## Manure Management Plan

**A response to Natural England's Comments: 21<sup>st</sup> April 2020**

**Application Reference NYM/ 2020/0182/FL**

**Proposal:** Removal of Chicken Shed and Construction of Equine Building, use of Land for Equine Purposes together with use of land for the siting of photovoltaic Panels

job no: BUT.A 2019.01 drawing no: 105

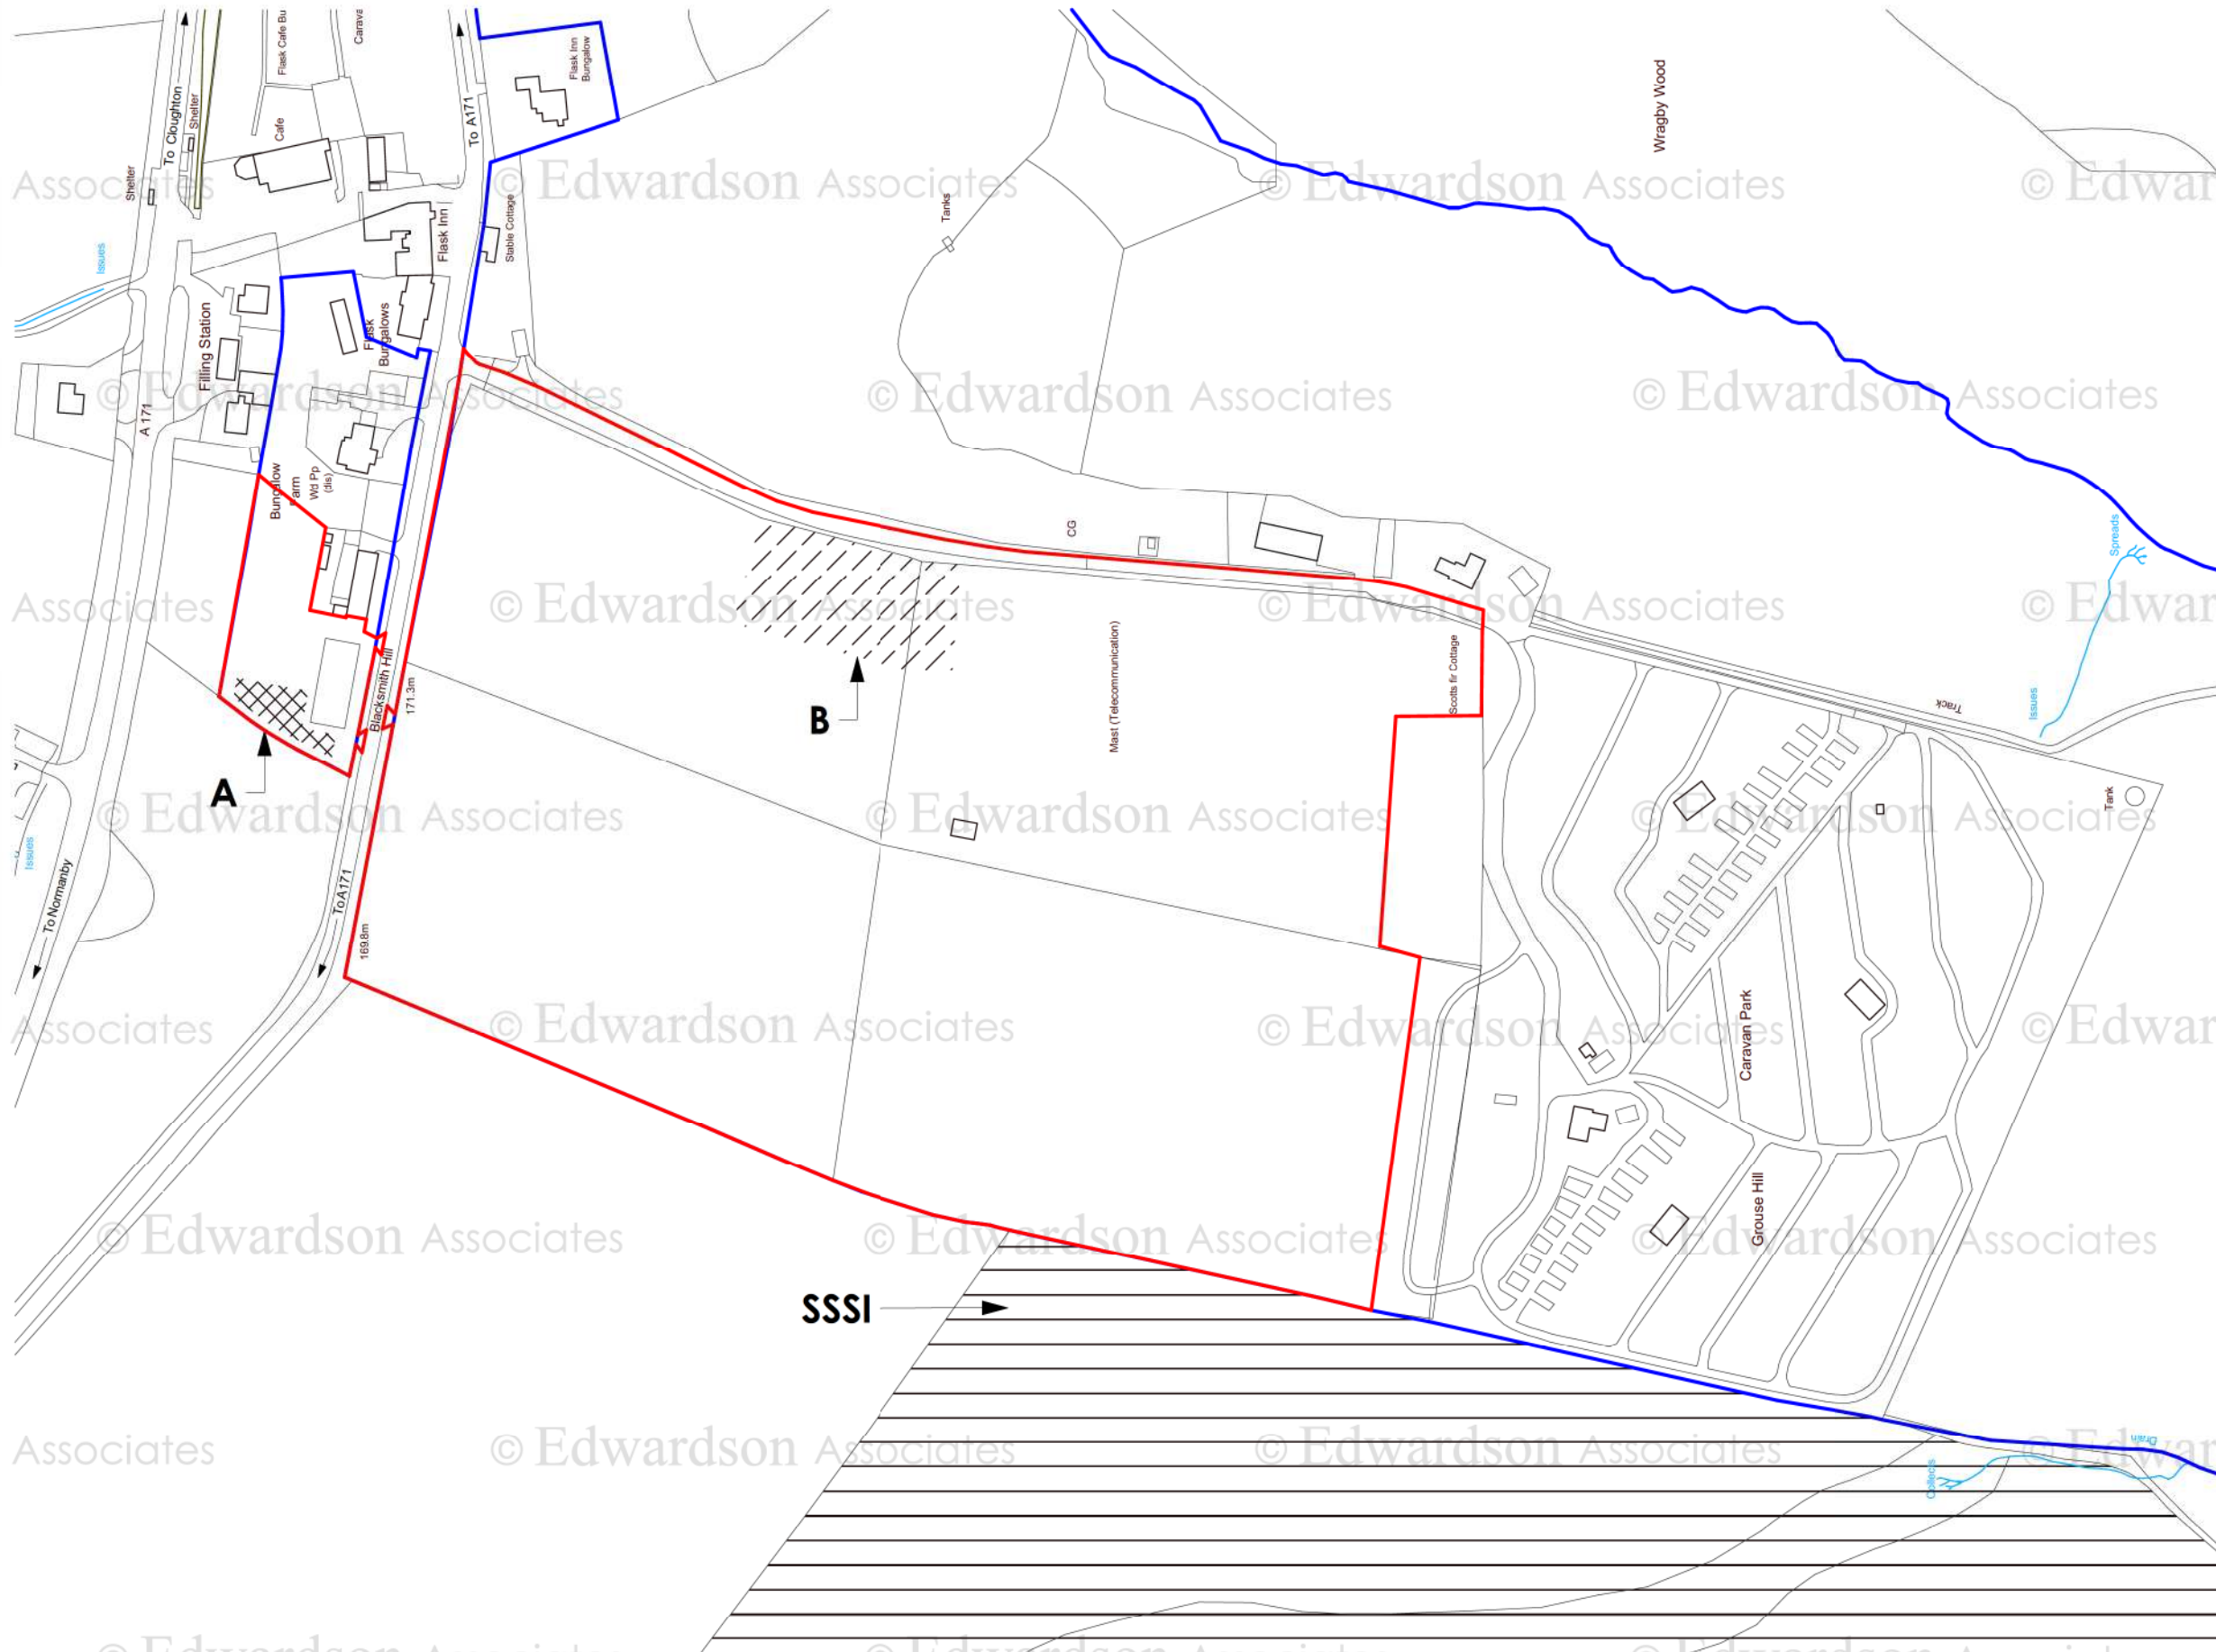
It is anticipated that the manure and soil bedding from the stables will be stored on a sealed trailer within the yard, to the north of the proposed equine stables. Please see hatched Area A on Plan 105. As the stable is brought into use the trailer will be transported and deposit the manure in an appropriate location within the farm holding.

The manure will be removed from Area A, approximately every 4 weeks, or more frequently in busy periods.

The Owners of Grouse Hill Caravan Park, Mr and Mrs Butterfield, will transport the manure on a tractor and trailer and spread this in the north-west corner of the application site. Please see Area B on Plan 105. Position B is proposed as it is some distance from The Biller Howe SSSI (as labelled on the plan.)
